Monroe Expressway 2026 Roadside Toll Collection System

Request For Proposals

Addendum No. 2

Issued 07/28/2026

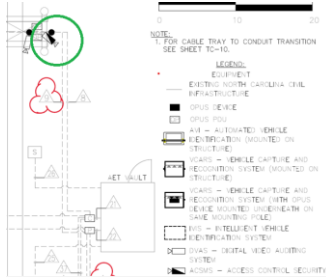
31.	78	4.1	General Infrastructure Considerations	Since this project involves the modernization/renovation of the existing RTCS toll gantries, is it assumed that the existing fiber optic infrastructure to the Equipment roadside cabinets can be used? Are there enough free fibers? If no: Please clarify the specific scope of work and requirements that must be considered for the new fiber optic installation.	There is a 12 strand drop from the trunk to the vault. There are at least 2 unused strands available for integrator use. Refer to TC-23 found in Attachment 4 for the fiber diagram. Connectivity from the vault to the roadside cabinets is the responsibility of the Contractor.
